REMARKS

AMENDMENTS TO THE DRAWINGS

Drawings
SON-2781
for 2781

FIG.1B

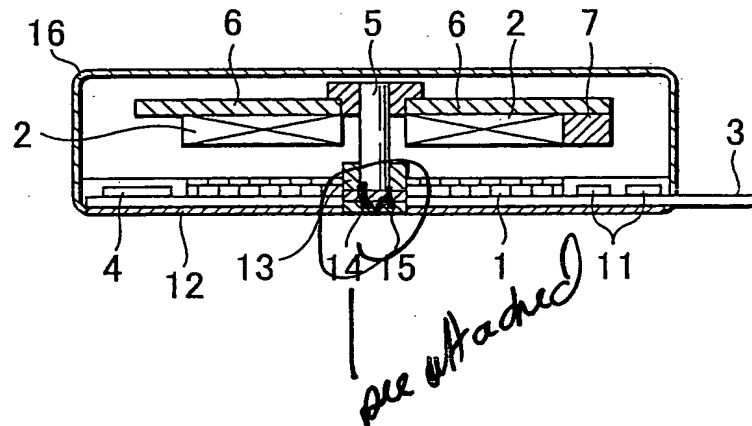
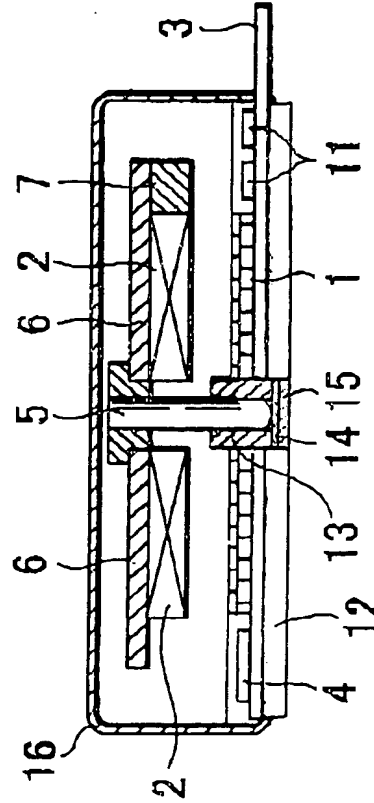
Sheet 1 includes Fig. 1B – the structure of the bottom plate 12, shaft 5, radial bearing 13 and thrust bearing 14 is harmonized with the method of manufacture, particularly as shown in Figs. 7 to 10, for example.

FIG.10A

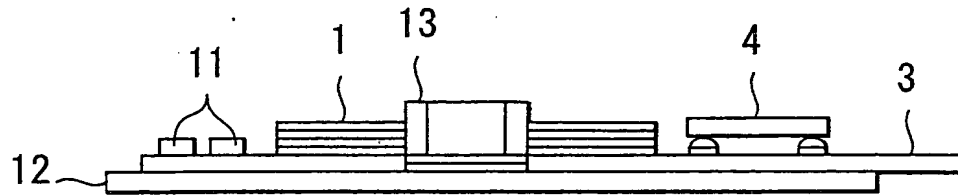
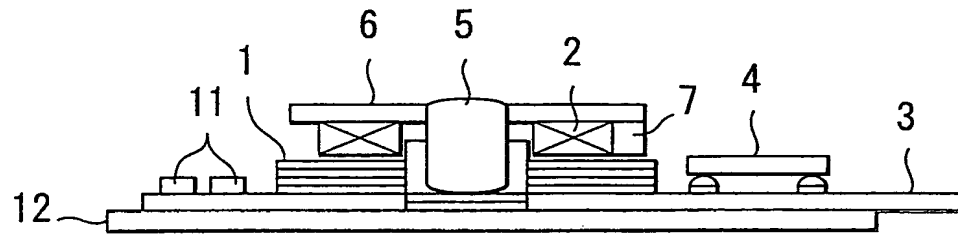
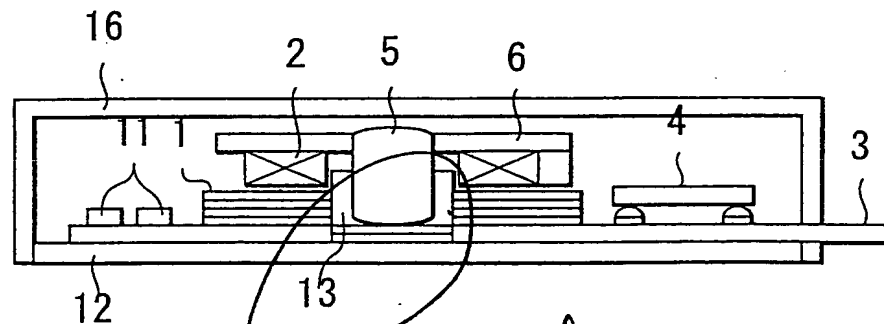
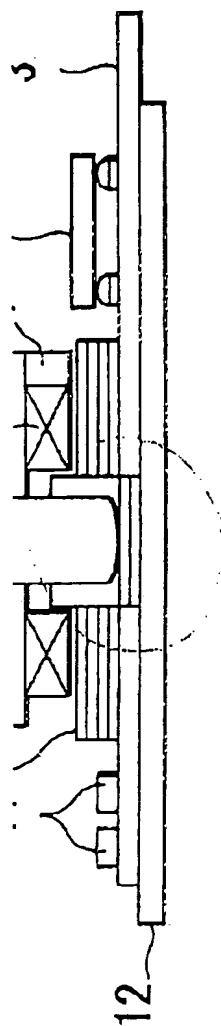
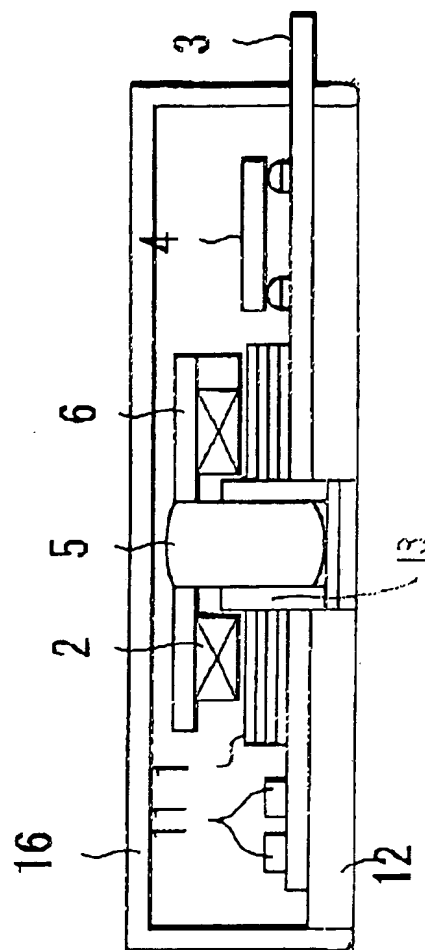
Sheet 2 includes Fig. 10A to 10C – the drawings are changed to show the shaft 5 and radial bearing 13 accurately relative to the bottom plate 12.

Same to FIG.10A to 10C

FIG.14A *Prior Art*

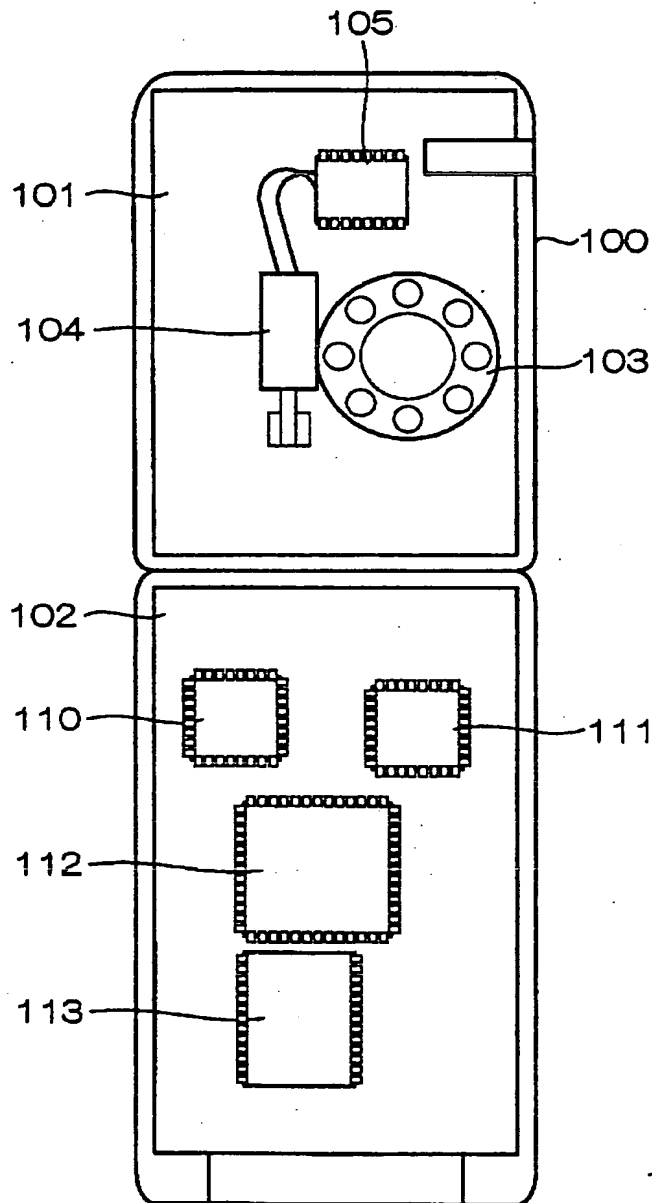
Changes are made to 1B, 10A to 10C and Fig. 14A and 14B as shown on the attached sheets. In particular, Fig. 14A and 14B has been amended to add the legend "Prior Art" as requested by the Examiner. This change is responsive to the points raised in section 4 on page 3 of the Action. Claims 4 and 5 are canceled and claim 3 included in claim 1 in a way that avoids the offending recitation of a motherboard.

Sheet 3 includes Fig. 14A and 14B – Please add the legend -- PRIOR ART --
